**1958 Agreement – Consideration of draft amendments  
to existing Regulations submitted by GRSG**

### **Proposal for the 03 series of amendments to Regulation No. 34 (Prevention of fire risks)**

#### **Submitted by the Working Party on General Safety Provisions \***

"Model B

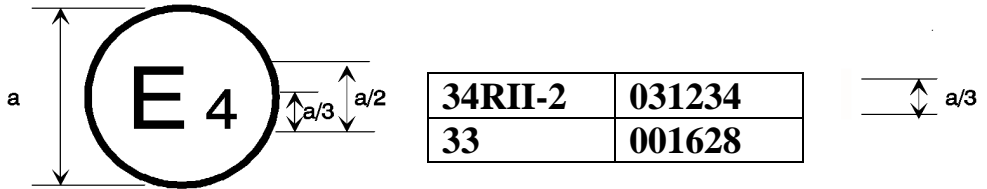
Annex 2, Model B, amend to read:

The above approval mark affixed to a vehicle shows that the type concerned was approved in the Netherlands (E 4) pursuant to Regulations Nos. 34 Parts I or IV and II-1 and 33\*. The approval numbers indicated that, at the date when the respective approvals were given, Regulation No. 34 included the 03 series of amendments and Regulation No. 33 was still in its original form.

The above approval mark affixed to a vehicle shows that the type concerned was approved in the Netherlands (E 4) pursuant to Regulations Nos. 34 Parts I or IV and II-2 and 33\*. The approval numbers indicated that, at the date when the respective approvals were given, Regulation No. 34 included the 03 series of amendments and Regulation No. 33 was still in its original form."
